Project Number: 25_160

Project Name: Exploration Place Museum GAHP Installation
(ITT No. FS-26-02)

Addendum No: 1

Figure 1. GAHP Sleeper Detail.

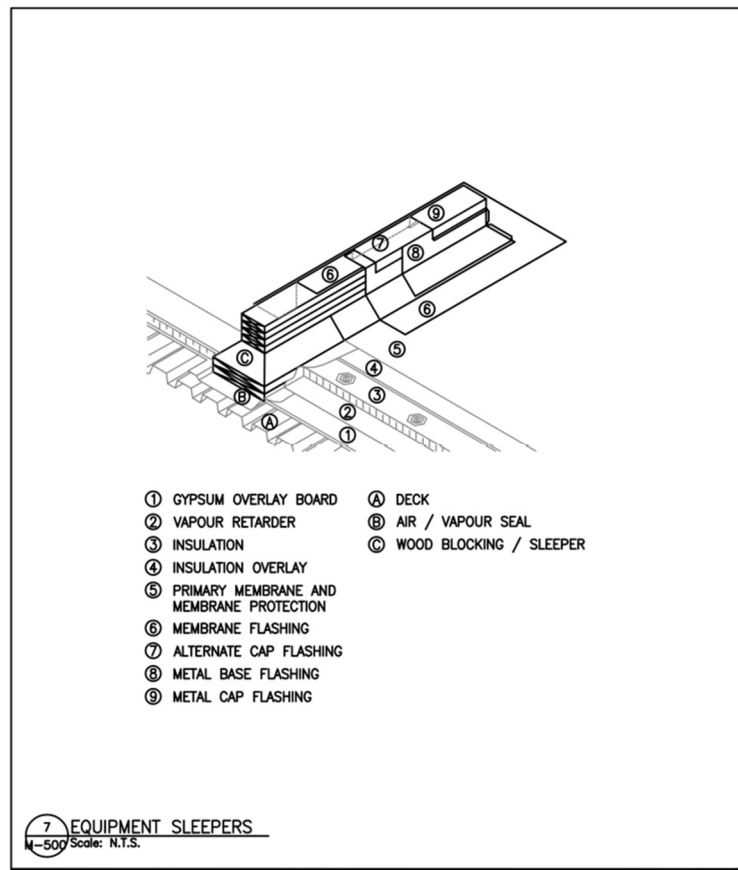
6. **Clarification:** Roof Curb Being Roofed In or Metal Roof Option

GAHP unit to be mounted on sleepers. Sleepers shall be properly roofed in and weather sealed. Refer to sleeper detail in Figure 1 below:
